UNITED STATES PATENT AND TRADEMARK OFFICE

APPLICATION NO.	FILING DATE	FIRST NAMED INVENTOR	ATTORNEY DOCKET NO.	CONFIRMATION NO.
10/566,865	01/31/2006	Lip Teck Soh	003D.0086.U1(US)	2241

Office Action Summary	Application No. 10/566,865	Applicant(s) SOH, LIP TECK	
	Examiner Phuongchi Nguyen	Art Unit 2833

DETAILED ACTION

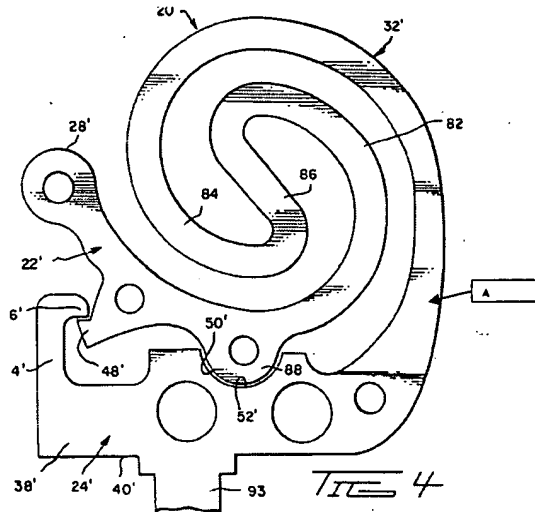
In regards to claim 1, Grabbe discloses an electrical connector comprising:

a connector housing (18')(figs. 4 and 5); and

at least one deformable connector terminal arrangement (of 20') disposed at the connector housing (18'), the connector terminal arrangement (of 20') comprising:

a terminal (20') comprising a movable resilient arm portion (32'+82+84+86), a contact portion (28') at one end of the resilient arm portion (32'+82+84+86) for connecting to a first electrical point (2) (fig. 1) and a support portion (24') connected to another end of the resilient arm portion (32'+82+84+86) and for connecting to a second electrical point (4, 96);

wherein the support portion (24') is seated in the connector housing (18'), and wherein the terminal (20') further comprises a contact tail portion (93) extending from the support portion (24') out of the housing (18');

a first pivot portion (A) for pivoting of the resilient arm portion (32'+82+84+86) relative to the support portion (24'); and

a second pivot portion (88) for pivoting of the contact portion (28') relative to the resilient arm portion (32'+82+84+86) (see marked-up below).

In regards to claims 5 and 20, Grabbe discloses the contact portion (28') comprises a bent segment having an arched portion/acute (see marked-up above).

In regards to claim 6, Grabbe discloses the connector wherein the terminal (20') further comprises the first pivot portion (A), disposed between the resilient arm portion (32'+82+84+86) and the support portion (24') (see marked-up above).

In regards to claim 33, Grabbe discloses the connector wherein the tail portion (93) comprises a first free end of the terminal (20') (see marked-up above).

In regards to claim 38, Grabbe discloses the assembly wherein the one or more resilient arm portions (32') are pivoted about the respective first pivot portions (A); and the one or more contact portions (28') are pivoted about the respective second pivot portions (88) (see marked-up above).

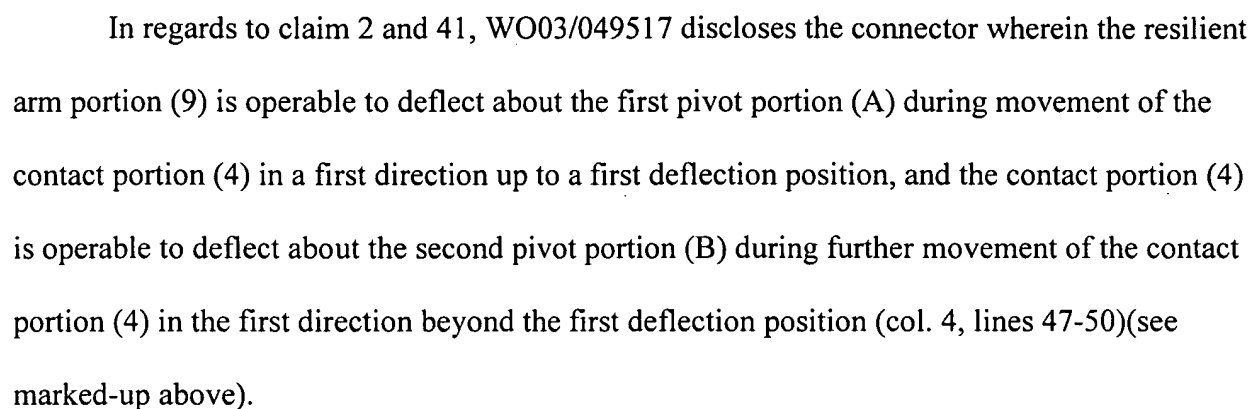
In regards to claim 1, WO03/049517 discloses an electrical connector comprising:

a connector housing (3); and

at least one deformable connector terminal arrangement (of 1) disposed at the connector housing (3), the connector

a terminal (1) (figs. 1-3) comprising a movable resilient arm portion (9), a contact portion (4) at one end of the resilient arm portion (9) for connecting to a first electrical point (of the first mating connector) and a support portion (8) connected to another end of the resilient arm portion (9) and for connecting to a second electrical point (of the second mating connector);

wherein the support portion (8) is seated in the connector housing (3), and the terminal (1) further comprises a contact tail portion (5) extending from the support portion (8) out of the housing (3);

a first pivot portion (A) for pivoting of the resilient arm portion (9) relative to the support portion (8); and

a second pivot portion (B) (fig. 2) for pivoting of the contact portion (4) relative to the resilient arm portion (9) (see marked-up below).

In regards to claim 6, WO03/049517 discloses the connector wherein the terminal (1) further comprises the first pivot portion (A), disposed between the resilient arm portion (9) and the support portion (8) (see marked-up above).

In regards to claim 17, WO03/049517 discloses the connector wherein the second pivot portion (B) is formed integrally with the resilient arm portion (9) (marked-up above).

In regards to claim 38, WO03/049517 discloses the assembly wherein the resilient arm portions (9) is pivoted about the respective first pivot portions (A); and the contact portions (4) are pivoted about the respective second pivot portions (B) (see marked-up above).
